## Design Memorandum No. 16-32 Technical Advisory

**SUBJECT:** Integral End Bent Depth

**REVISES:** *Indiana Design Manual* Section 409-2.04(02), Figures 409-2C and 409-2D

**Figure 409-2C  
(Page 1 of 4)**

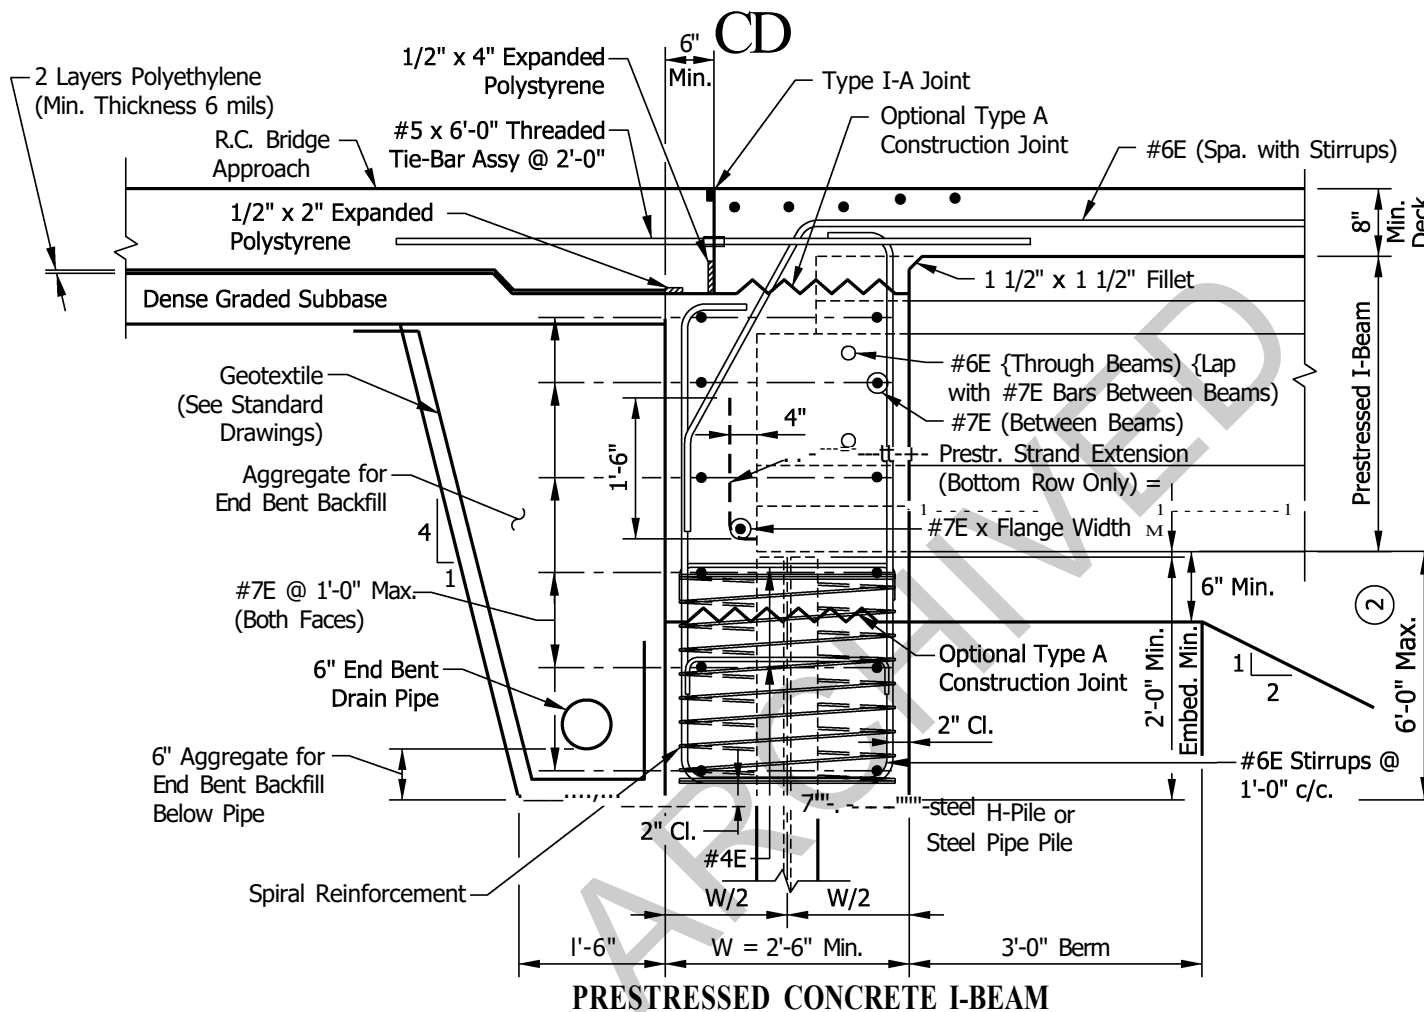
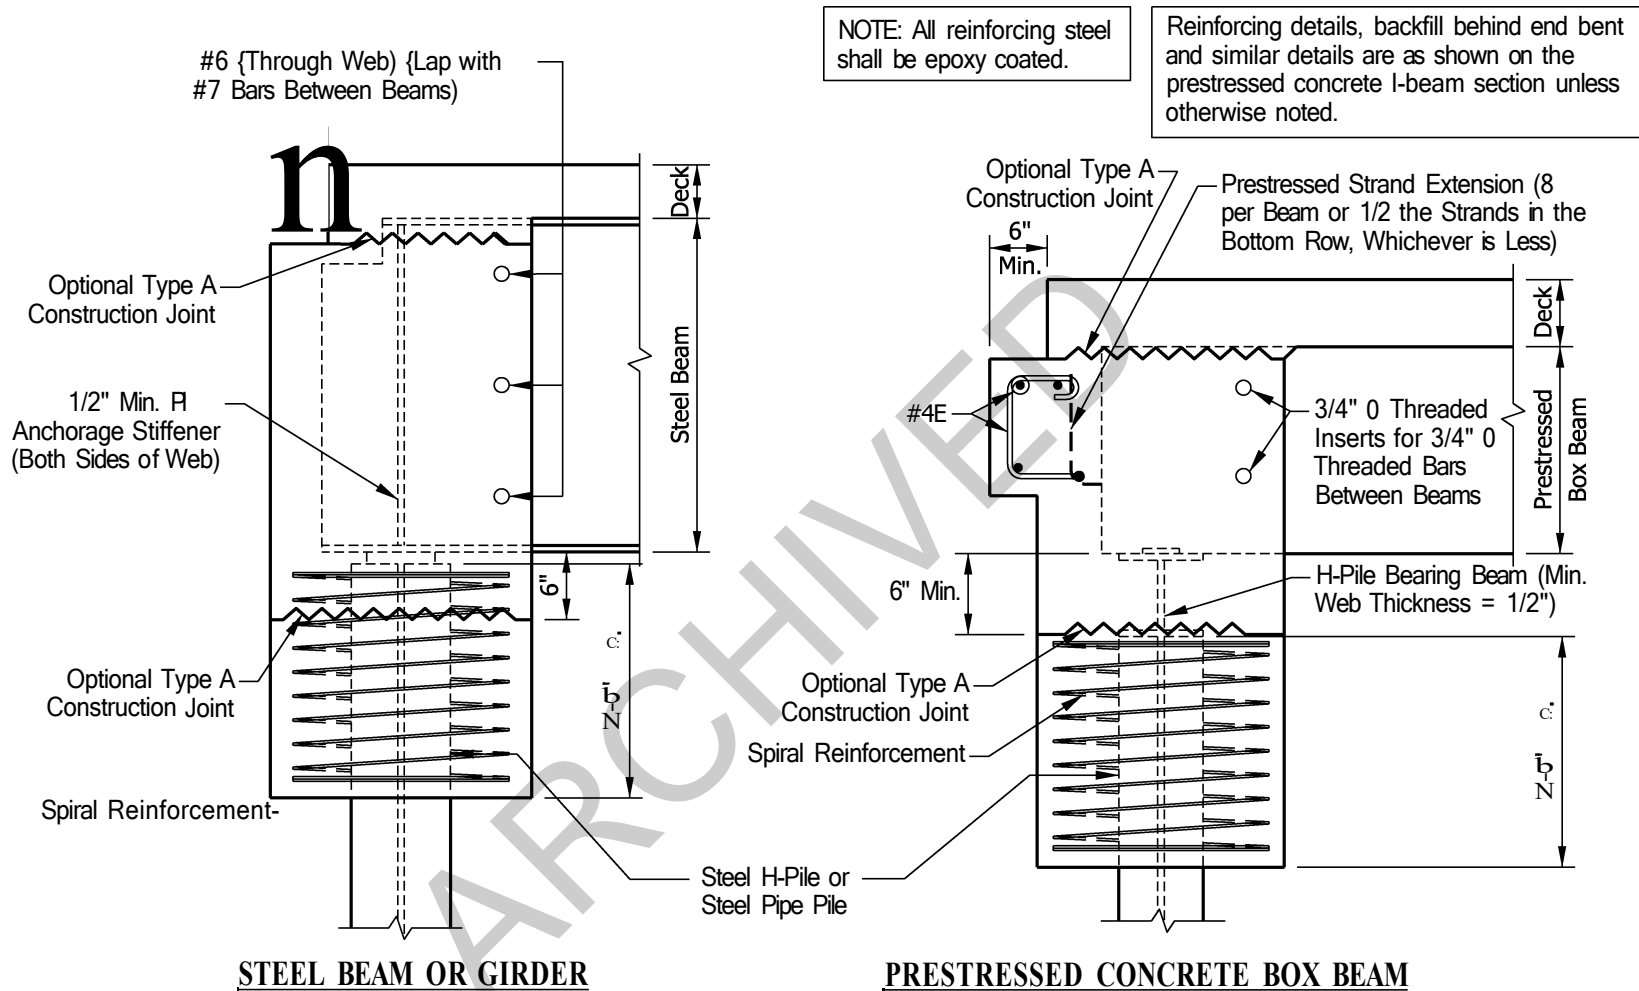
The Department is implementing a maximum allowable integral end bent depth of 6 feet as measured from the bottom of the beams to the bottom of the bent. Integral end bents deeper than 6 feet will be considered on a case by case basis, but will require coordination with, and approval from the Office of Bridge Design.

1. Width. The width shall not be less than 2.5 ft.
2. Depth. The depth from the bottom of the beam or girder to the bottom of the integral end bent should not exceed 6'-0". Use of a deeper end bent must be approved by the Bridges Division Office of Bridge Design.

- (D) A pavement ledge greater than 6 in. may be considered for skewed structures or structures subject to significant truck traffic.
- O A depth greater than 6 ft requires approval from the Office of Bridge Design.
- 3. All reinforcing steel shall be epoxy coated.
